RE: DENYING AN APPEAL (AP23- 002) AND AFFIRMING THE PLANNING COMMISSION'S APRIL 11, 2023 ACTION APPROVING AN ENVIRONMENTAL AND DESIGN REVIEW PERMIT (ED22-016) FOR A NEW MIXED-USE BUILDING WITH 162 RESIDENTIAL UNITS AND 8,900 SQUARE FEET OF GROUND FLOOR COMMERCIAL SPACE LOCATED AT 1515 4TH STREET AND DETERMINING THE PROJECT EXEMPT FROM THE CALIFORNIA ENVIRONMENTAL QUALITY ACT PURSUANT TO CEQA GUIDELINES SECTION 15332

1515 FOURTH STREET ASSOCIATES, LLC (the Applicant) is writing in response to the Appeal (AP23- 002) filed by Vikram Seshadri regarding the April 11th Planning Commission approval of the 1515 4th Street Project (the Project). The appeal fails to raise any significant, quantifiable, direct, and unavoidable impacts of the project, based on objective, identified written public health or safety standards, policies, or conditions as they existed on the date the application was deemed complete as required by the Housing Accountability Act (Government Code Section 65589.5). Accordingly, the Appeal has no merit and the Applicant requests that the City Council deny the Appeal.

**1515 4th Street - AMG Traffic Appeal Letter
Of Response**

1515 4th Street - AMG Traffic Peer Review

PLAN AT
GROUND LEVEL

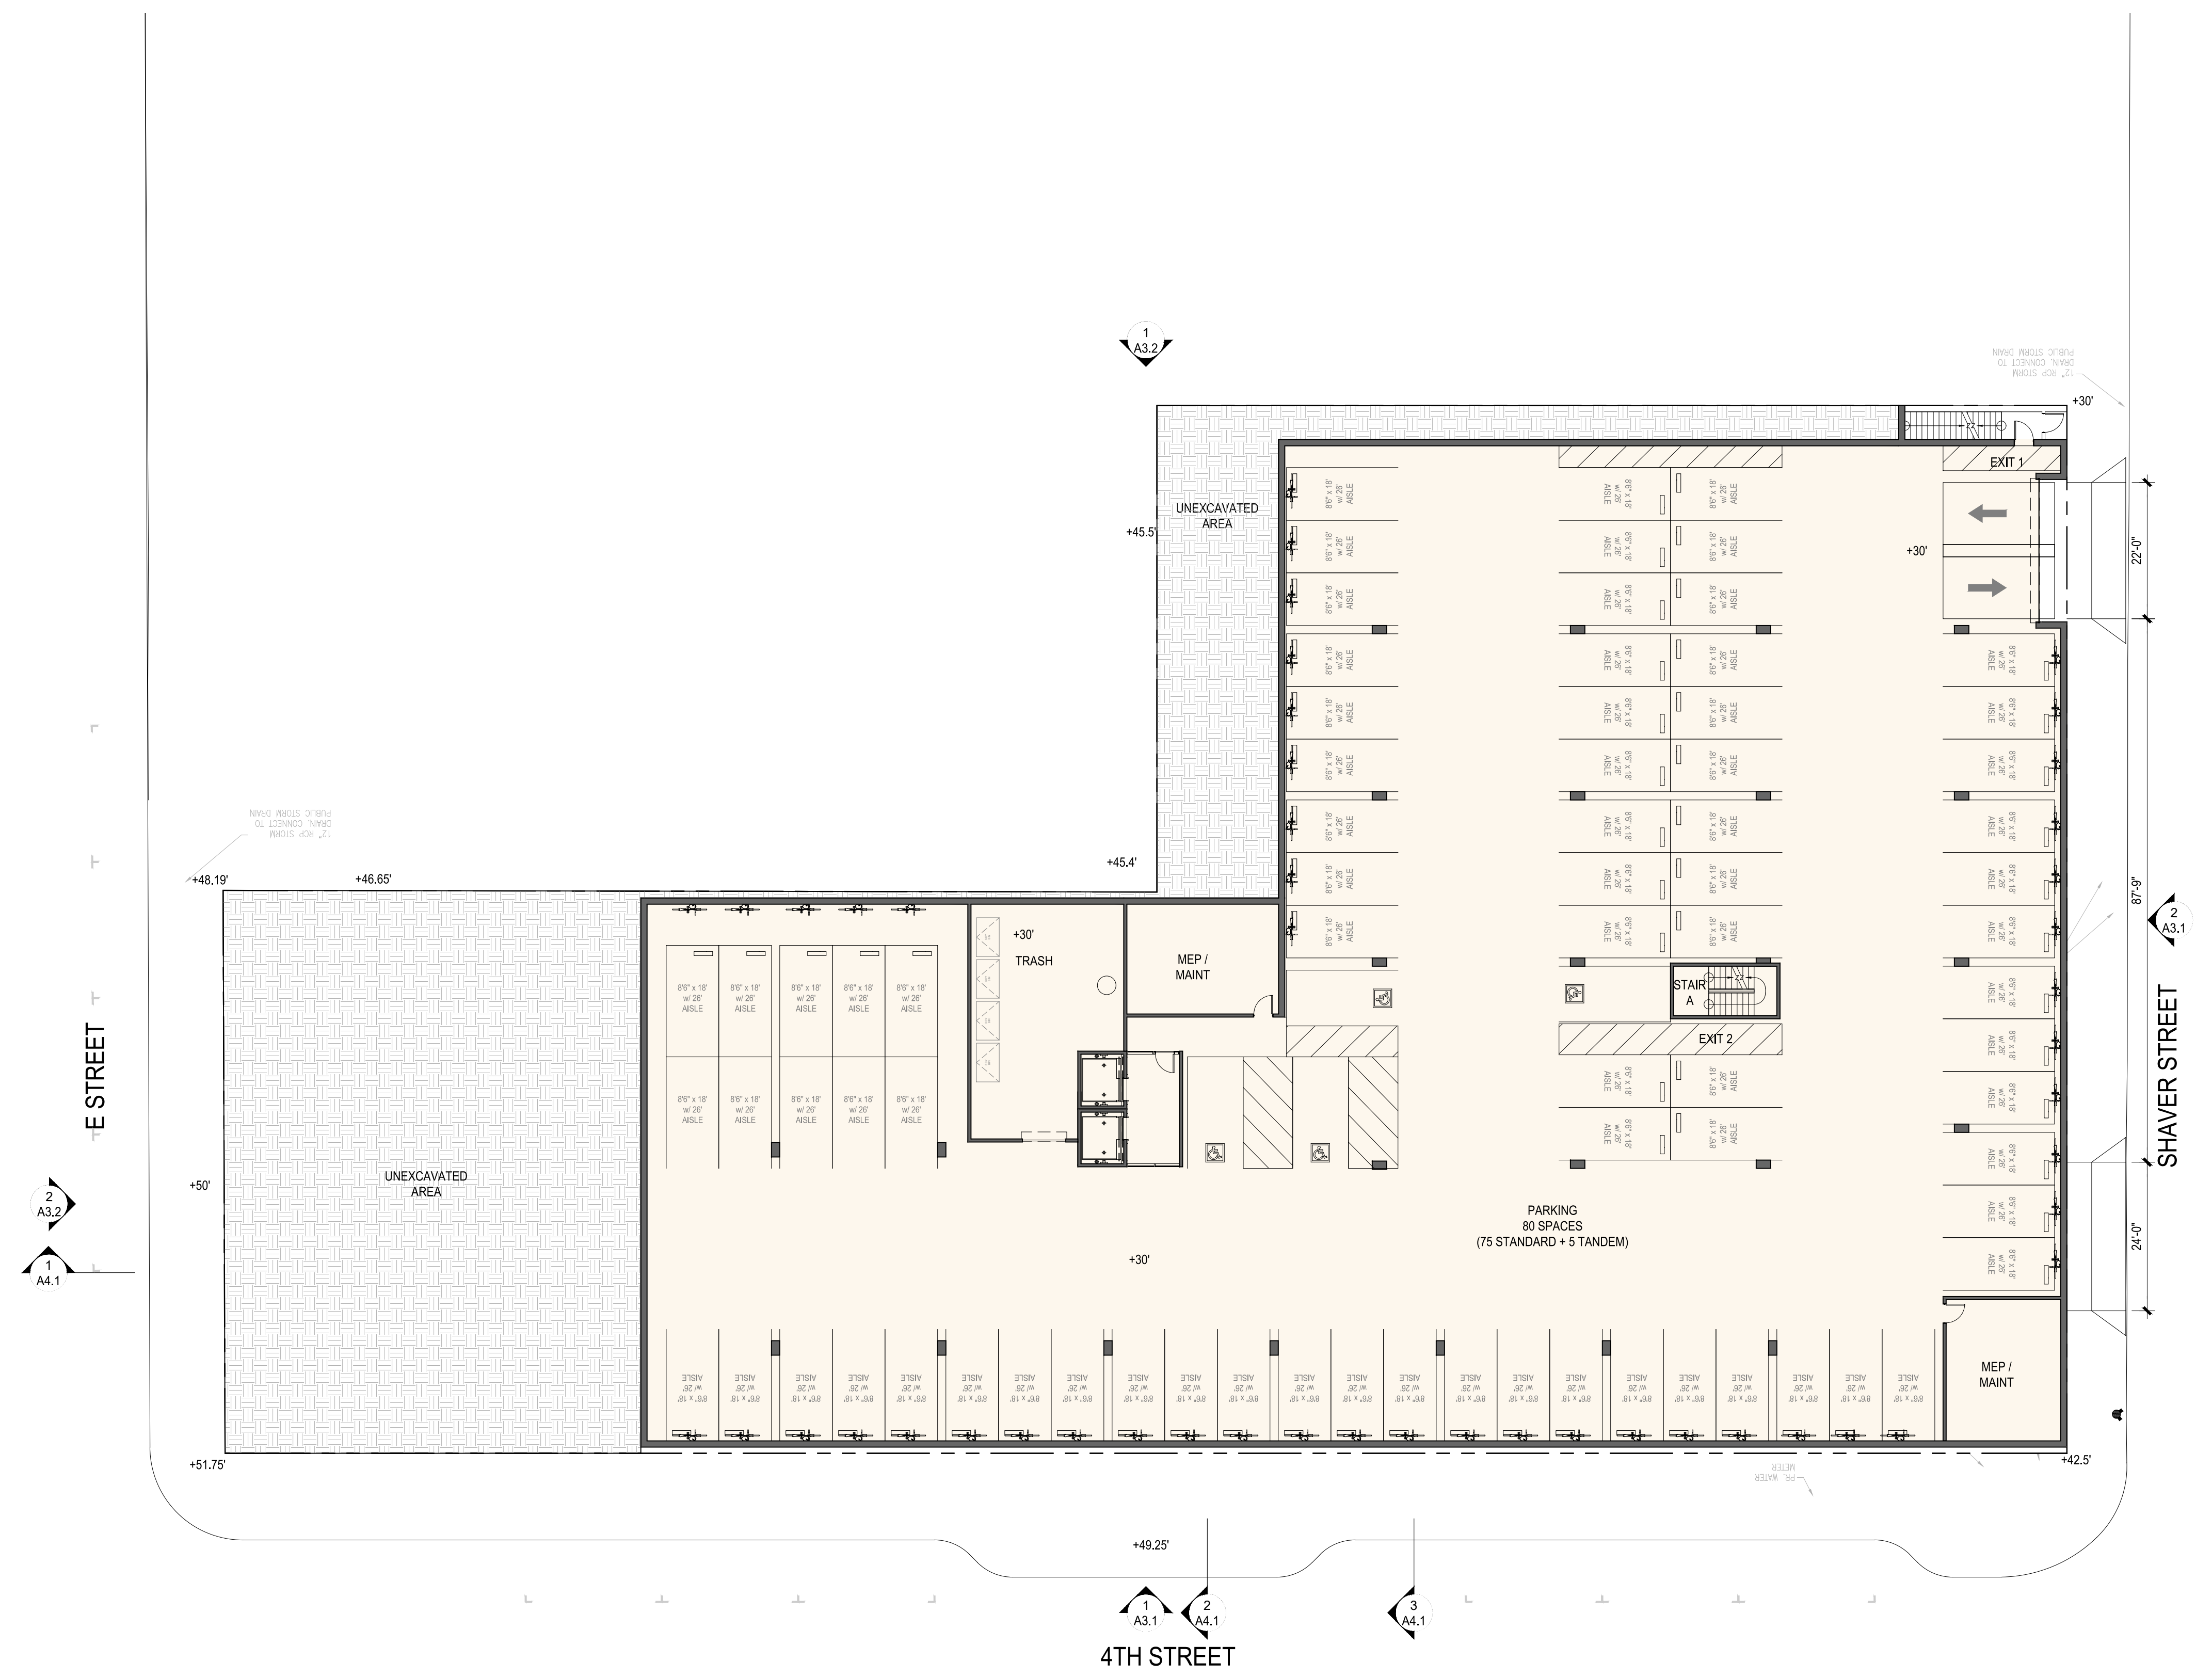
The project site plan shows two site access driveways to be located on Shaver Street while pedestrian access will be on E Street. There is a discussion on the stopping sight distance for vehicles, however, there is no discussion on the sight distance between the exiting vehicle and pedestrians on the sidewalk. The sight distance between exiting vehicles and pedestrians is critical if the access driveways (garage driveways) have solid walls on both sides of the driveway while the sidewalks are narrow. In this situation, motorists exiting the garage driveways may not be able to see pedestrians in time to stop until the front end of the vehicle reaches the middle of the sidewalk, thus creating unsafe conditions for pedestrians. This is especially crucial for vehicles exiting (emerging) from the underground garage, which will make it even more difficult for motorists and pedestrians to see each other.

separated by an 18-inch planting strip acting as a buffer between pedestrians and the project driveways providing additional safety for pedestrians. This planting strip “buffer” was mentioned under the Roadway Assessment section of our LTA. A flashing light system will be installed at each driveway to alert pedestrians of any vehicles exiting the driveway, providing additional safety.

AMG properly assessed the site access of the project driveways. Each driveway will have a lane in each direction separated by a concrete median. A security gate will be installed at each driveway, which will open with a remote control. The width of each lane will be between 11 – 12 feet, which will provide sufficient room for vehicles to enter. These features are shown in Appendix A of the LTA.
